August 31, 2021

Project No. 2114

**RE: 2054 Gordon Street, Guelph – Springfield Golf Course
Technical Review of H6**

Maps

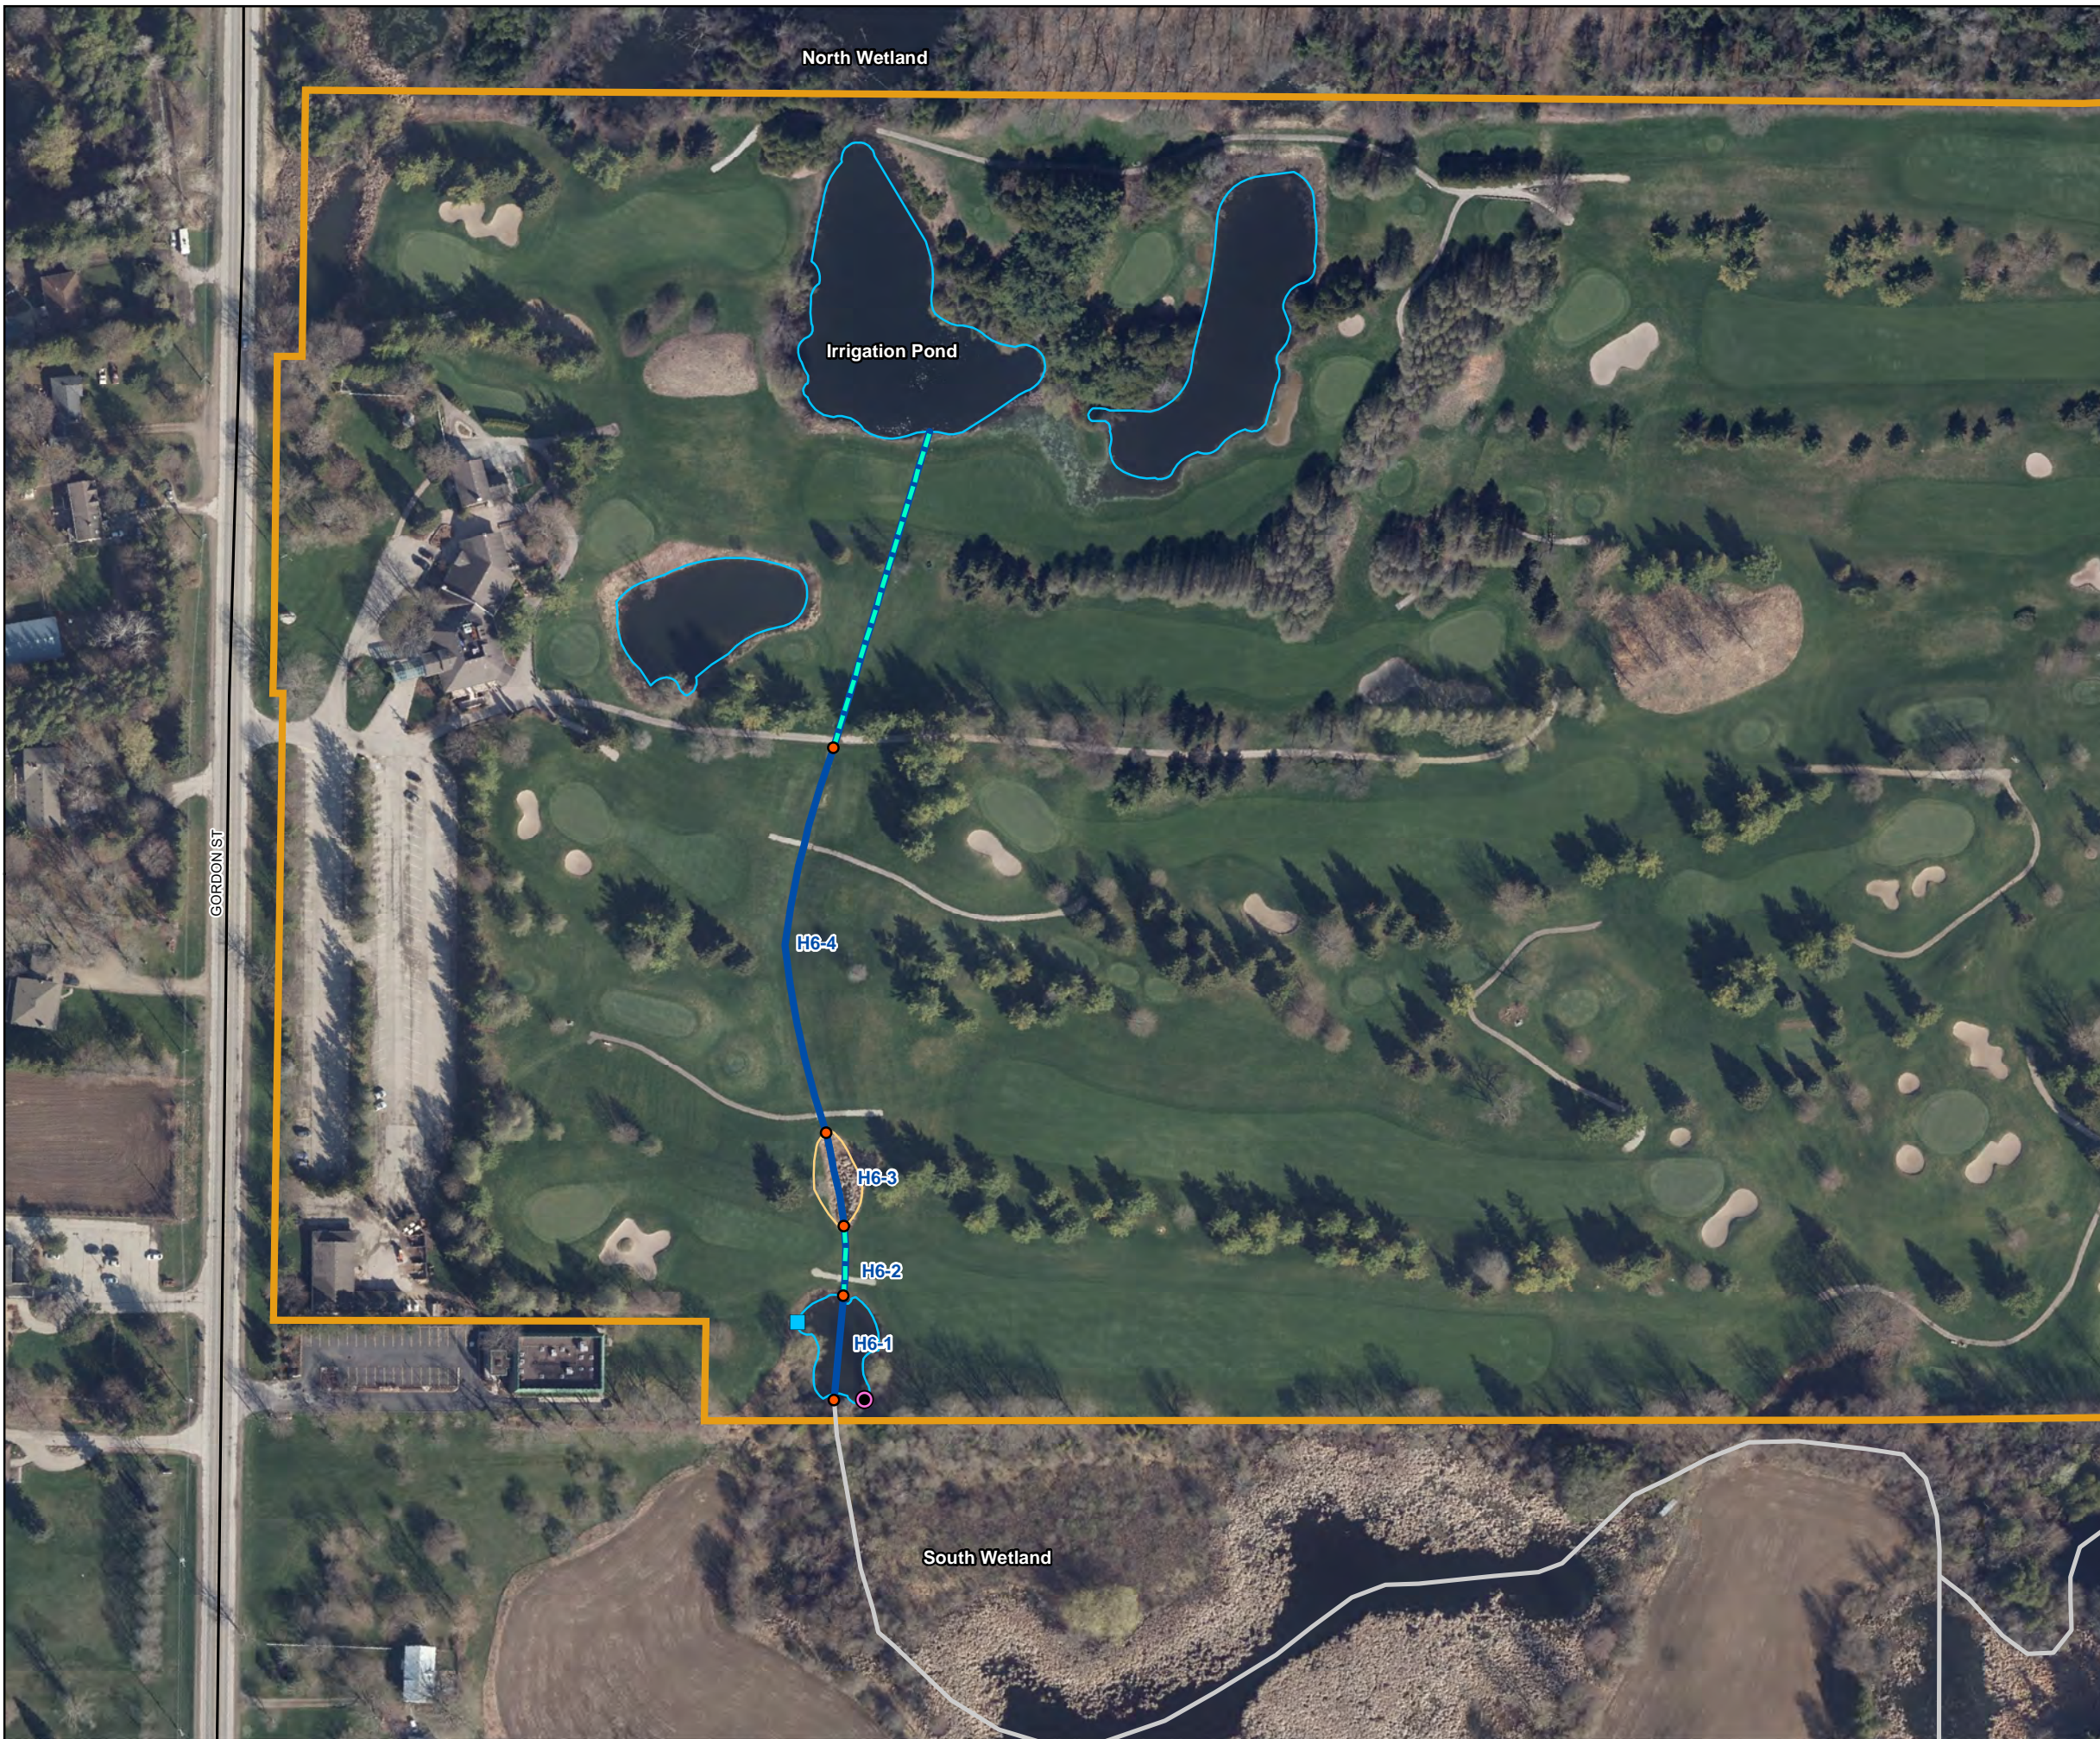
There are 4 segments of H6, labeled 'H6-1' through 'H6-4' as shown on Map 1. Representative photographs of each segment are provided in Appendix I. The following paragraphs describe H6 from north (H6-4) to south (H6-1) and additional site conditions as observed during site visits.

Segment **H6-4** is 120m long and extends from the 0.3m csp at the southern end of the buried tile drain area to a small wetland (H6-3) (Map 1). It passes under a small wooden golf cart span bridge as well as through a 0.15cm PVC pipe below a second paved golf cart path just north of H6-3. Segment H6-4 is categorized as a *no defined feature* using the OSAP Feature Type codes (Feature Type 4). During the preliminary visit in 2019, golf course maintenance staff indicated that no tile drain is present in this area. The segment was dry during all 3 visits in 2021. During the preliminary site visit on April 9, 2019, the minimal flow observed exiting the buried tile drain pooled in the upstream area of H6-4, creating an area of standing water and saturated soils. However, standing water conditions continued for approximately 80m only, and the remainder of the segment was dry. Vegetation within and adjacent to segment H6-4 is manicured lawn.

Segment **H6-3** is a small, 0.02ha marsh feature comprised almost entirely of cattails (*Typha* sp.) (OSAP Feature Type 6). Standing water was present during visits 1 and 2. By visit 3, the segment was dry (although damp soils were observed). Riparian vegetation consists of manicured lawn. During site visits in 2021, wildlife observed using this small patch of cattails was limited to a few Red-winged Blackbirds (*Agelaius phoeniceus*) during visit 2 (May 7, 2021) and an adult Gray Treefrog (*Hyla versicolor*) during visit 3 (August 4, 2021). Segment H6-3 is currently mapped as a wetland by the GRCA; however, new information collected as part of the CEIS has resulted in the recommendation that the small marsh be excluded from GRCA wetland mapping as shown on Map NH-5A (Beacon 2021).

Water from segment H6-3 discharges to a buried tile drain that characterizes segment **H6-2** (Map 1). The tile drain extends for approximately 27m from the marsh feature to a small wooden golf cart span bridge. The tile drain discharges underneath a wooden golf cart span bridge (Appendix I) before entering the pond to the south (segment H6-1). No flow was observed exiting the tile drain during any of the site visits in 2021. During the preliminary visit on April 9, 2019, minimal flow was observed draining to segment H6-1.

Segment **H6-1** is a man-made stormwater management (SWM) pond measuring 30m in length and 20m in width, and is generally encircled by a narrow (3-8m) band of naturalized riparian vegetation and manicured lawn. The pond was constructed specifically to convey flows to the wetland south of the subject property. The segment receives inputs from both H6-2 and a second tile drain that enters the pond at its western corner via a small headwall (Appendix I). While H6-2 was not flowing during any 2021 visit, minimal flow was observed exiting the second western tile drain on visit 1 (March 19 2021) only. A catch basin in the southeastern corner of the pond provides flow conveyance via a pipe to the south wetland. Water overtopped the invert of the catch basin on visit 1 (March 19, 2021) only. Segment H6-1 is currently mapped as a wetland by the GRCA; however, new information collected as part of the CEIS has resulted in the recommendation that the SWM pond (like segment H6-3 above) be excluded from GRCA wetland mapping as shown on Map NH-5A (Beacon 2021).

Based on the site conditions observed in 2019 and 2021, and a review of the CEIS and associated mapping (Beacon 2021), NRSI requests that H6 be removed from future iterations of Map NH-4A of the CEIS and Schedule E of the Clair-Maltby Secondary Plan, as well as other mapping related to the Clair-Maltby Secondary Plan and Subwatershed Study. H6 is not an HDF as defined by the Headwater Guideline and OSAP headwater modules. It does, however, provide flows to the wetland south of the subject property for a brief period in the early spring, as it was designed to do. The restrictive 'Protection' management recommendation that has been put forth in the CEIS should not be applied to H6 because it is not an HDF, and has been significantly modified by golf course activities that have altered its form and function.
